# Redevelopment of Loreto Kirribilli School Modification 2

External design amendments and installation of a new  
kiosk substation  
State Significant Development Modification Assessment  
(SSD 7919 MOD 2)

September 2020

Published by the NSW Department of Planning, Industry and Environment

**Figure 3 |** Approved roof level (left) and proposed roof level (right) (Source: Applicant's Modification Report)

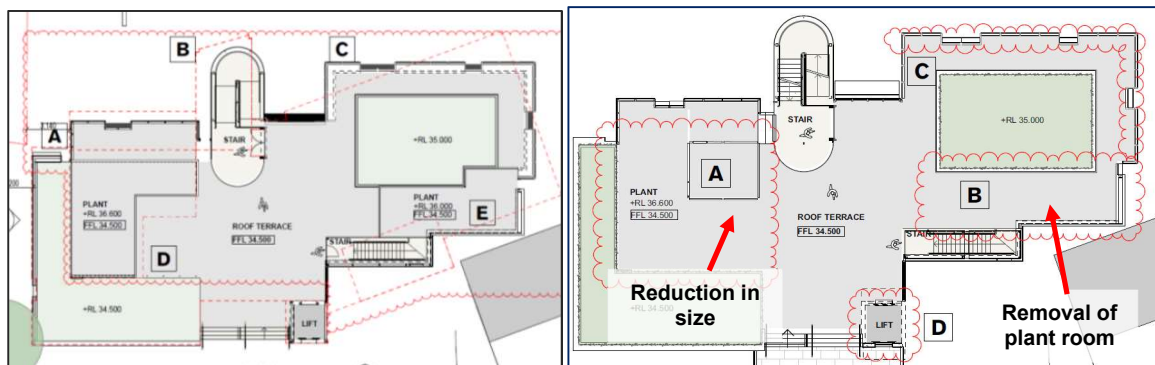
Modifications to the roof level include a reduction in the size of the plant room to the west of the roof level and removal of the plant room to the east of the roof level. **Figure 3** provides a comparison of the approved and the amended layout of the rooftop plan for the Innovation Centre building.

The Applicant advised that the proposed increase in extent of excavation would provide opportunity to locate services below ground and at the ground level driveway, thus reducing the size of the rooftop plant room. The removal of the plant on the eastern side of the roof would result in a minor change to the configuration of the approved landscaped area. This area would continue to be non-trafficable.

**Figure 4 |** Approved roof level light scoop (left) and proposed roof level arrangement (right) (Source: Applicant's Modification Report)

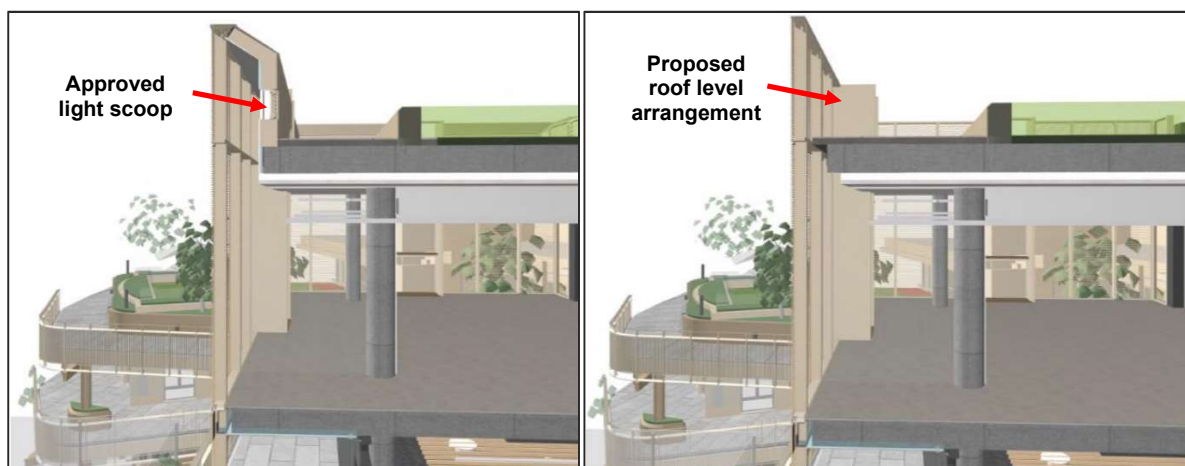
A high-level window / 'light scoop' window at the roof level is proposed to be removed and the roof slab extended to the approved screen along the northern elevation (**Figure 4**). No amendments to any elevation would be needed due to this modification.

**Figure 6 |** Approved western elevation (left) and proposed western elevation (right) (Source: Applicant's Modification Report)

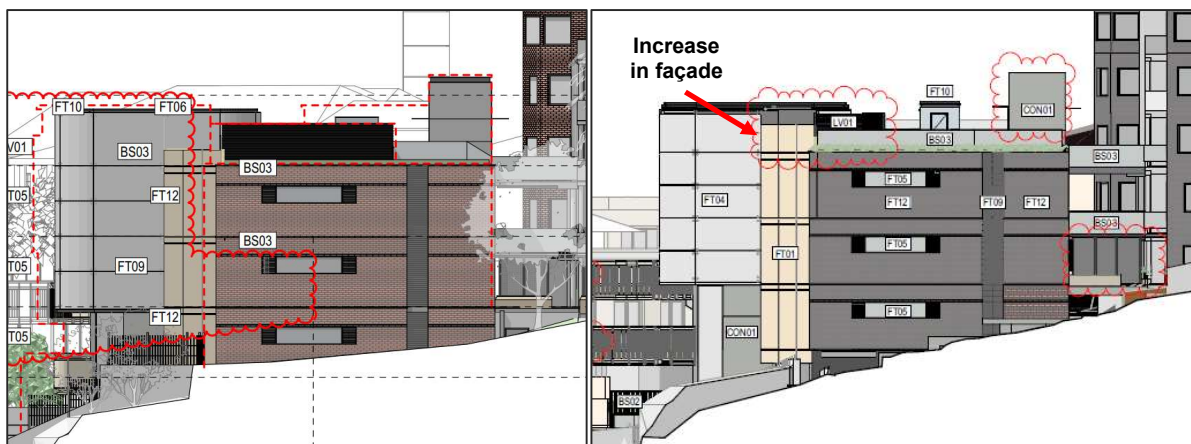
The height of the screen enclosing the Elamang Avenue façade of the Innovation Centre is proposed to be increased at the north-west corner, to improve safety. The façade, at this corner, would comprise fixed full height glazing with integrated screen, to allow for natural light. While the height of the screen is proposed to be increased marginally, the building structure or the approved RLs would not be modified. The top level of the screen would align with the maximum building height of the envelope approved under the Concept Proposal (see **Figure 6**).

The modification proposes an increase in the height of the screen enclosing the façade at the north-western corner of the Innovation Centre building to improve safety (**Figure 19**). This increase is higher than that approved under SSD 7919 MOD 1, however, remains consistent with the original approval SSD 7919. As identified in **Figure 19**, the Department considers that the proposed increase in the height of the screen is marginal (about 1.5m) and within the approved height of the original envelope. Consequently, no additional view loss of the neighbouring properties are anticipated due to the proposed change.

**Figure 7 |** Approved western elevation (left) and proposed western elevation (right) (Source: Applicant's Modification Report)

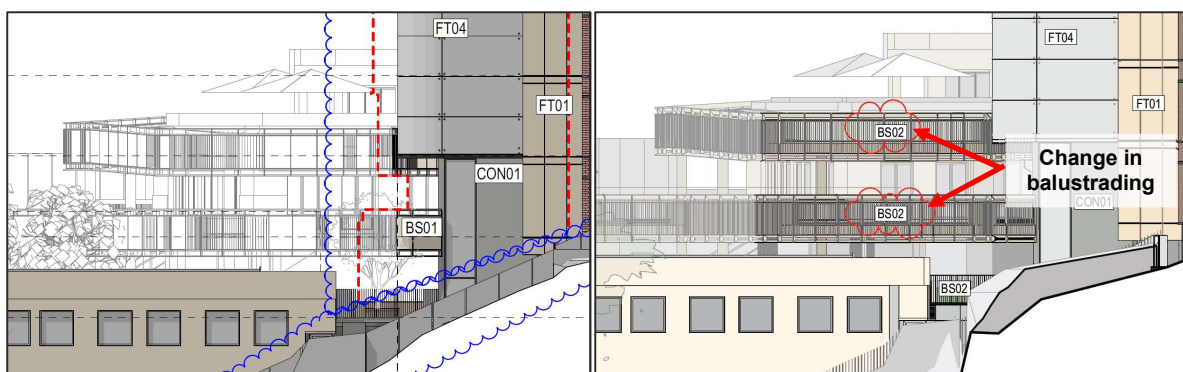
The modification application proposes to amend the materiality of the balustrade at ground level and lower ground level 1 from a combination of solid concrete / palisade to a continuous palisade balustrade for consistency with the rest of the balustrades along this elevation (see **Figure 7**).

**Figure 8 |** Proposed location of new kiosk substation (Source: Applicant's Modification Report)

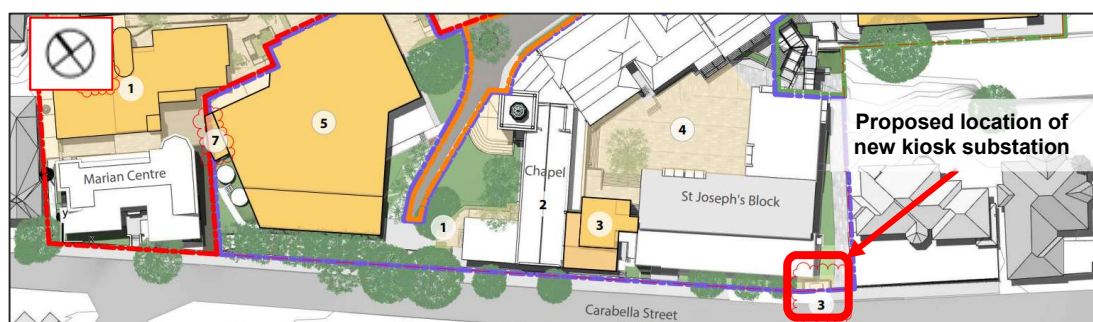
A new 1000 kilovolt (kVA) kiosk substation is proposed to service the Innovation Centre, as well as future stages of the Concept Proposal. The substation is proposed to be constructed on a suspended slab, on a 5.3 metre (m) x 2.05m easement on the site's Carabella Street frontage, in front of the existing J-Block (**Figure 8** and **Figure 9**).

**Figure 9 |** Proposed location of new kiosk substation from Carabella Street frontage (Source: Applicant's Modification Report)

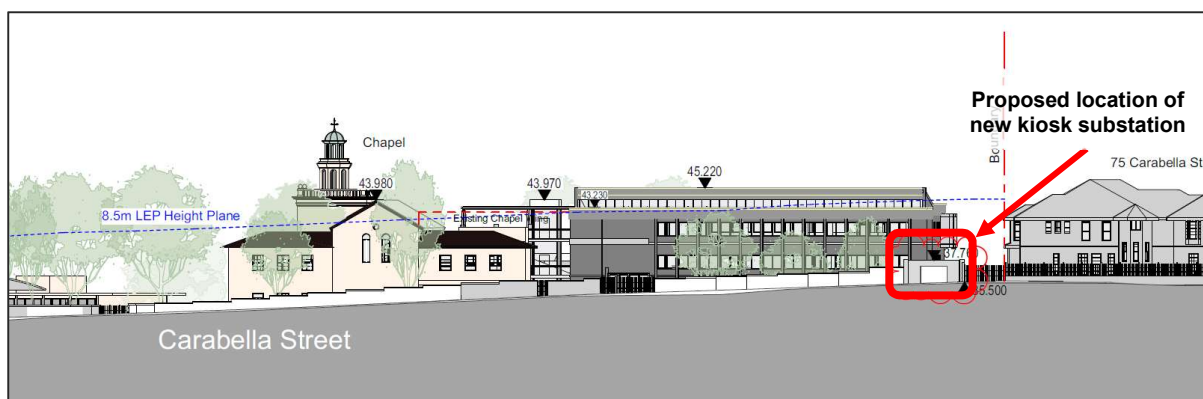
Installation of the substation would require the removal of an existing pillar and a small part of the rendered wall fronting Carabella Street. The substation would be recessed to sit in-line with the reconstructed wall. The new retaining wall around the sides and rear of the substation are proposed to be constructed of reinforced concrete 'block' to prevent any blast from the substation impacting the school.

**Figure 11 |** Approved (left) and proposed (right) ground level of Elamang (Source: Applicant's Modification Report)

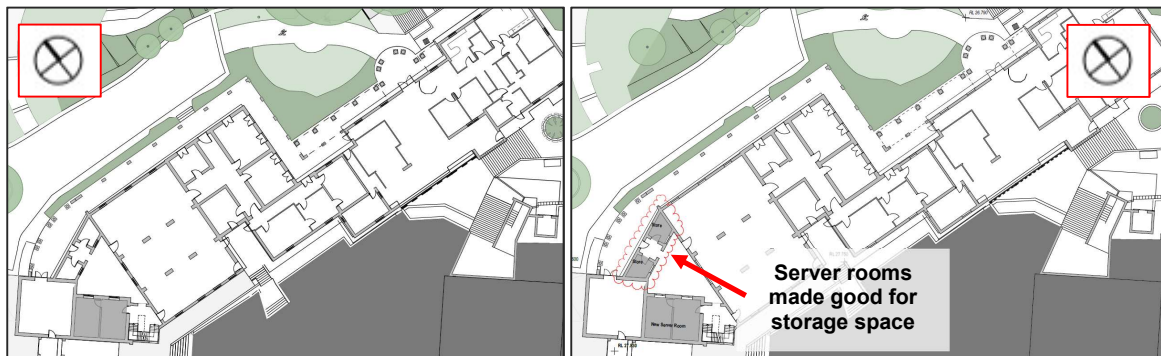
- make-good works to the existing server rooms at ground level of the Elamang Building for reuse as storage space (**Figure 11**).
- minor refurbishment works to create new offices at Level 2 of the J Block (**Figure 12**).
- reconfiguration of the external ramp and stair to the north of the Marian Centre (**Figure 13**).

Modifications to Elamang include refurbishment the existing server rooms at ground level of the Elamang Building for use as storage space.

**Figure 12 |** Approved (left) and proposed Level 2 of J Block (right) (Source: Applicant's Modification Report)

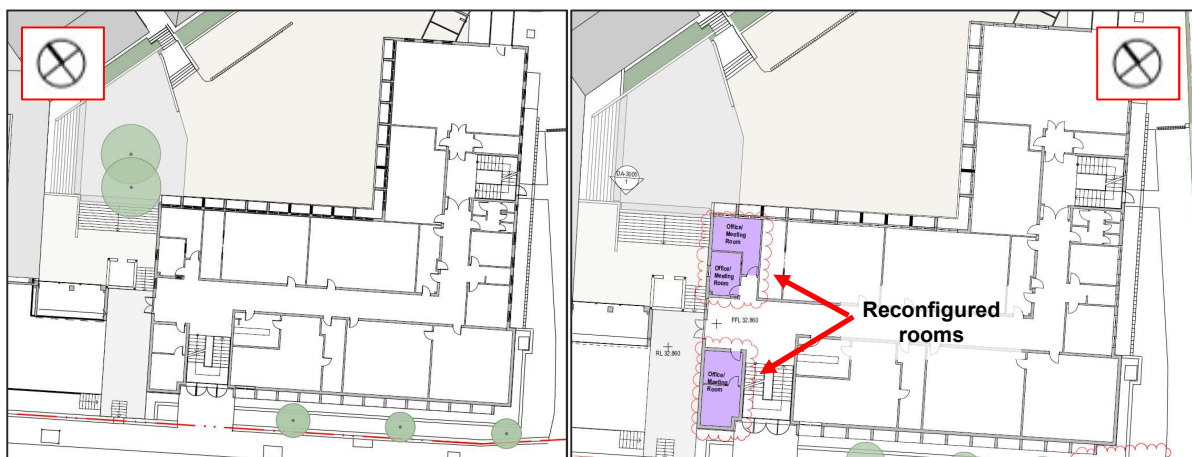
The HIA submitted by the Applicant concluded Elamang is of exceptional heritage significance and J-Block is of moderate heritage significance. Minor internal amendments are proposed to J-Block including refurbishments to create new offices/meeting rooms at Level 2.

**Figure 16 |** 3D render of the proposed substation and surrounding wall (Source: Applicant's Modification Report)

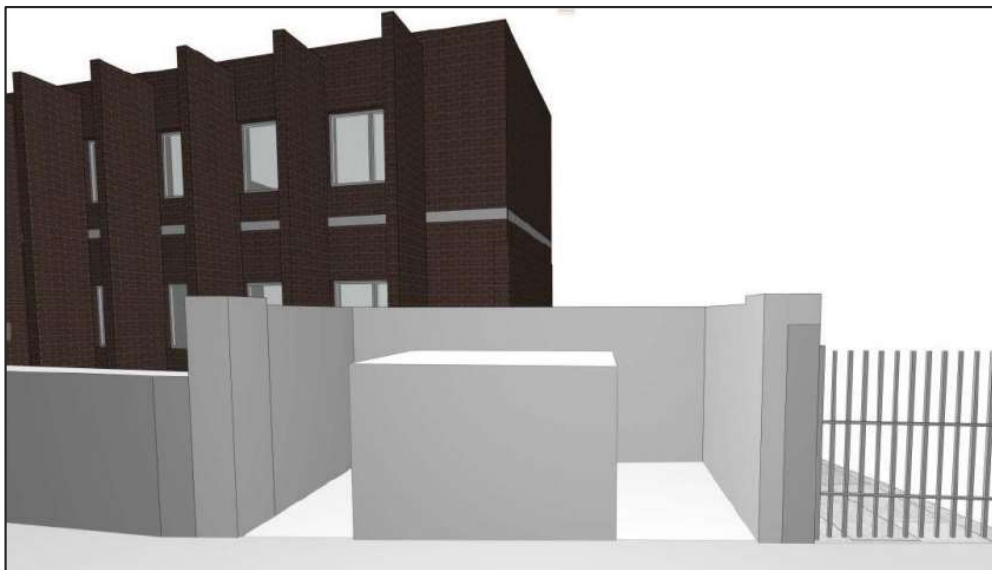
The Applicant has submitted a Heritage Impact Assessment (HIA) addendum which concludes the J-Block and Carabella Street boundary wall, where the substation is proposed (see **Figure 15**), has moderate heritage significance. However, the HIA concludes the proposed location would have the least impact on the heritage significance of the site whilst meeting the requirements of Ausgrid. The potential heritage impacts would be mitigated through the design of the new wall, which would be rendered and painted to match the existing (see **Figure 16**).

Based on the conclusions of the Applicant's HIA and the comments from Council, the Department concludes the proposed location of the substation and alterations to the school's boundary wall would have minimal impact on any elements of the site that have a significant heritage value.

The Department is satisfied that the proposed materials and finishes would not compromise the significance of the existing building on the site or the adjoining HCA. The location and design of the substation are considered suitable for the site and would provide the necessary connection required for the efficient functionality of the Innovation Centre.
